**CITY OF OLYMPIA**  
**Olympia Design Review Board**

**CONCEPT DESIGN REVIEW**  
**STAFF REPORT**  
**February 27, 2025**

<b>Case Number/Name:</b>	21-2854 West Bay Yards
<b>Project Representative:</b>	Thomas Architecture Studio
<b>Site Address:</b>	1210 West Bay Drive
<b>Project Description:</b>	Development of 478 multifamily residential units in 5 buildings atop a single story of structured parking. Project includes ground floor commercial, public trails, street frontage improvements, and shoreline restoration work.
<b>Comprehensive Plan:</b>	Urban Waterfront
<b>Zoning District:</b>	Urban Waterfront
<b>Design Review Criteria:</b>	18.110 Basic Commercial and 18.155 West Bay Drive.
<b>Notification:</b>	Notice of the Design Review Board Meeting was posted, mailed adjacent property owners within 300 feet of the site, and sent to parties of record on February 7, 2025.
<b>Board Responsibility:</b>	The Board will make a recommendation to the Community Planning and Economic Development Department (CPED) Director regarding the adequacy of the project’s design. This application is for conceptual design review and requires review of the applicable design criteria within the Olympia Munici

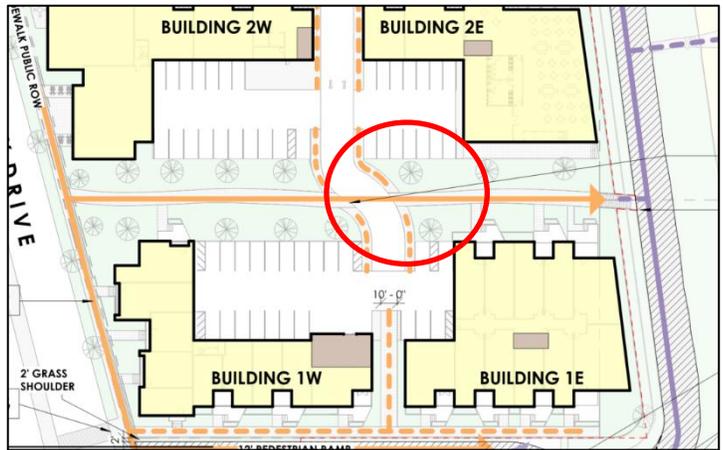
The project has applied for the maximum height bonus allowed by code. Plans are drawn with the assumption the bonus will be granted. The Board's review should focus on the plans as shown. Should the height bonus be denied or reduced, the building design would likely be significantly altered, and additional design review would probably be warranted. The height bonus is relevant to the design review in a few ways:

- 1) The pedestrian promenade / trail is provided and wraps around the building at the ground level. This pathway is required for the height bonus and will be required to be dedicated to the City. Building design from these vantage points are relevant to some of the design criteria.
- 2) View preservation is addressed in the City's code in three distinctly different places, all with nuancedly different requirements. The Board's preview applies to the Basic Commercial Design Criteria related to preservation of views. The Board does not have review authority over other code sections such as the Shoreline Master Plan.
- 3) View Corridors are required by the Municipal Code, and must be larger (wider) when buildings are taller. The distance between each tower is intended to meet view corridor requirements and cannot be reduced in width.
